L-2025-170
10 CFR 50.90
October 29, 2025

RE: Turkey Point Nuclear Plant, Units 3 and 4
Docket Nos. 50-250, 50-251
Subsequent Renewed Facility Operating License Nos. DPR-31 and DPR-41

Fleet License Amendment Request 25-01, Adopt Topical Report AMS-TR-0720R2-A, Online
Monitoring Program

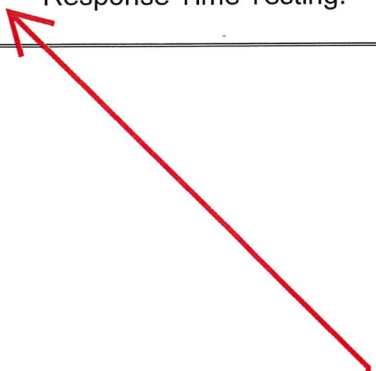
Insert:

Alternately, the use of the allocated ESF RESPONSE TIME for transmitters in the Online Monitoring Program is supported by the performance of online monitoring using the 'noise analysis' technique to detect dynamic failures modes that can affect transmitter response time.

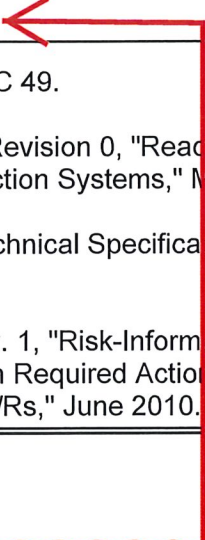
Insert:
5. AMS-TR-0720R2-A,
"Online Monitoring
Technology to Extend
Calibration Intervals of
Nuclear Plant Pressure
Transmitters."

Insert:
Alternately, the Frequency for checking the calibration of pressure, level, and flow transmitters may be determined in accordance with the Online Monitoring Program implemented in accordance with AMS-TR-0720R2-A (Ref. 5) and TS 5.5.18, Online Monitoring Program.
